Reply to report #1 by referee #2

The paper by Totems et al. is a comprehensive study on different bias sources in Raman lidar measurements of temperature and water vapor mixing ratio, including mitigation strategies. The paper is not only interesting for this type of tropospheric lidar, but some aspects can be transferred to all other types of lidars. For instance, the spatial inhomogeneities of PMT sensitivity or questions of range-dependent beam overlap can be crucial for other lidars, too. After a general description of the potential bias sources and their mitigation (or at least quantification), the authors apply this information to their own Weather & Aerosol Raman lidar WALI. The authors document that WALI fulfills the criteria set by WMO.

Reply to report #2 by referee #1

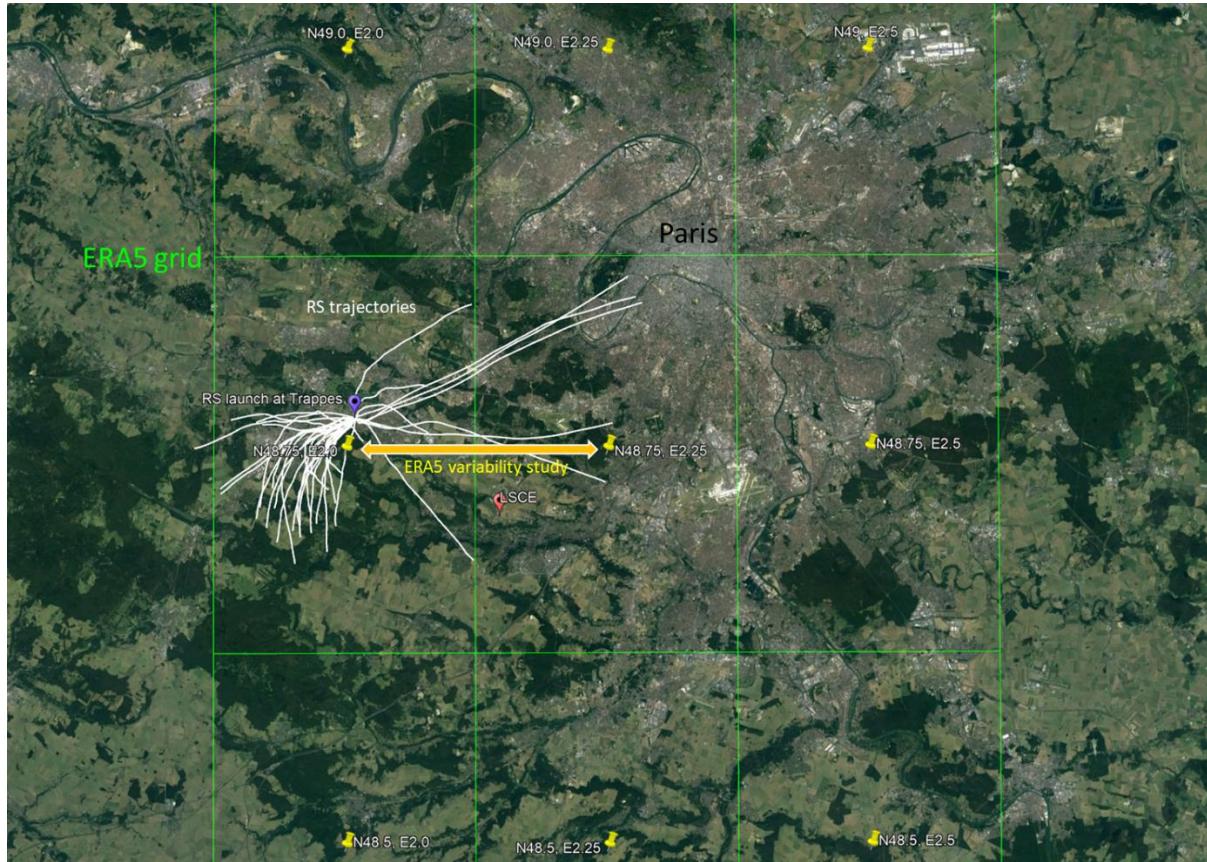
l. 653: Please provide the distances between lidar/radiosonde and their respective closest ERA5 gridpoint, and between these two gridpoints.

Has the drift of the radiosonde been taken into account or is the drift during the ascent up to 6 km much smaller than the distance between LSCE and Trappes sites (and ERA5 gridpoints)?

In the attached figure, we provide a map showing the position of the RS launching station at Trappes, the lidar at LSCE, the ERA5 grid points and “pixel” limits, and the RS trajectories up to 6 km. We hesitated about adding this as an appendix, but it does not seem necessary to make such a large addition to the paper and it would take too much time to make it a proper copyright-free map.

According to ERA5 reanalyses, the ground-level wind was mostly from the NE (except a few occurrences of NW and SW winds) and at most 10-15 km/h for this period. This led a lot of the radiosondes to drift away from both Trappes and LSCE, yet a majority remained in the “pixel” of Trappes (see attached figure).

Given that our need was for an estimation of the horizontal variability of the fields between lidar and radiosondes, we feel that the variability from one grid point to the next (yellow arrow), is a good representation for this. We did not go so far as to follow the drift of the radiosondes.

In the table caption, we have added: “The grid points are located 8 km WNW of the lidar and 2 km S of the RS station respectively, 18.3 km apart, and almost all RS trajectories below 6 km altitude are contained within the same “pixel” of the ERA5 fields.”
